**Re: Request for Information – DA2025/0117 for Demolition works and construction of a dwelling house including a swimming pool and cabana at 12 Molong Street, NORTH CURL CURL**

Reference is made to Council's letter dated 6 May 2025 and the request for additional information in order to undertake a full assessment of the application. It is noted that the following documents are provided as revised documents:

Figure 1 - Photograph Standing – Balcony off Bedrooms - Existing

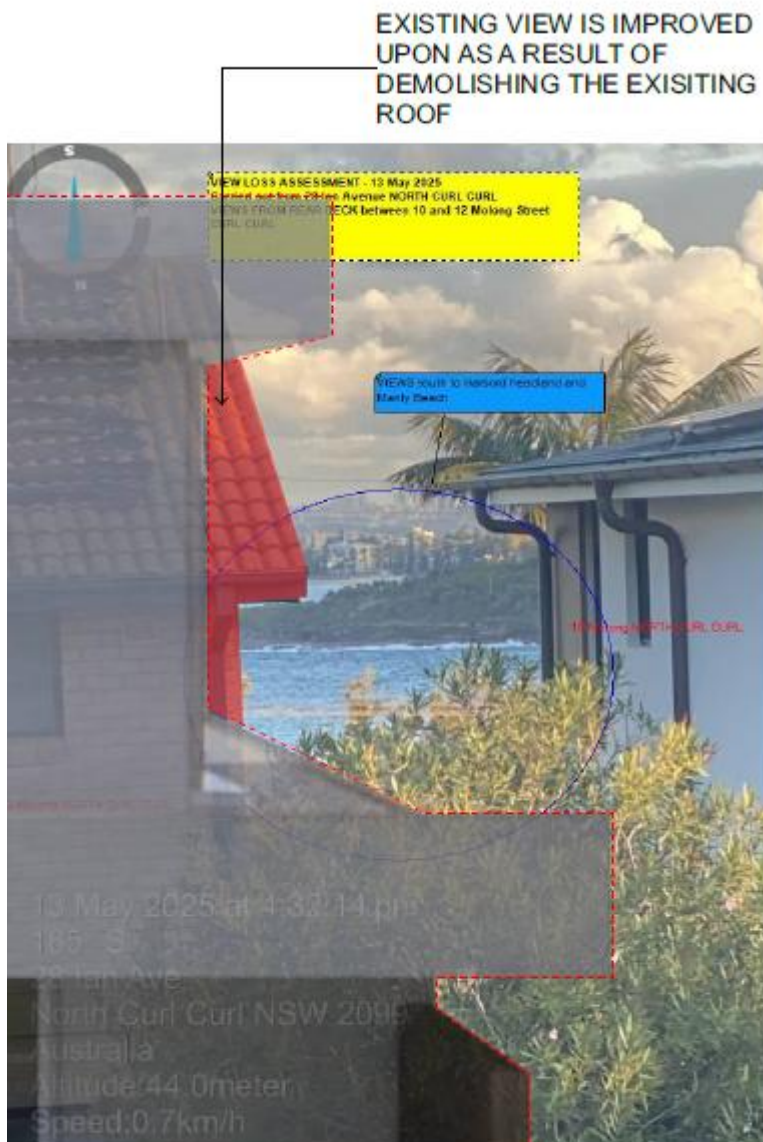
The views to be affected include filtered ocean views of Freshwater Headland towards Manly. It is important to note that the affected views are not considered to be iconic. Images below show existing and proposed views.

The views are available from the balcony off the bedroom level only from a standing position only. The views are obtained across rear and side boundaries.

The views affected towards the south/south-west from the bedroom balcony are shown in Figures 1 to 2. It is important to note that proposal will actually increase the view corridor, therefore the impact is negligible and retains with no impact the key viewpoints to Freshwater Headland and Manly. It is also noted that in our opinion where the view is achieved that a privacy screen should be in place to prevent overlooking of my client's property. When considering the views that are retained for the whole property, we have formed the considered opinion that the potential view impacts are deemed to be negligible (as the view corridor is improved).

As outlined the proposed development complies with the building height, wall height and setback provisions. It is further noted that figures 1-2 also show that the view corridor will actually be increased (not reduced). Given the building is well under the maximum building height and complies with all other relevant planning controls, it is considered to be reasonable and entirely consistent with how the site could reasonably be developed noting the built form of surrounding dwellings.
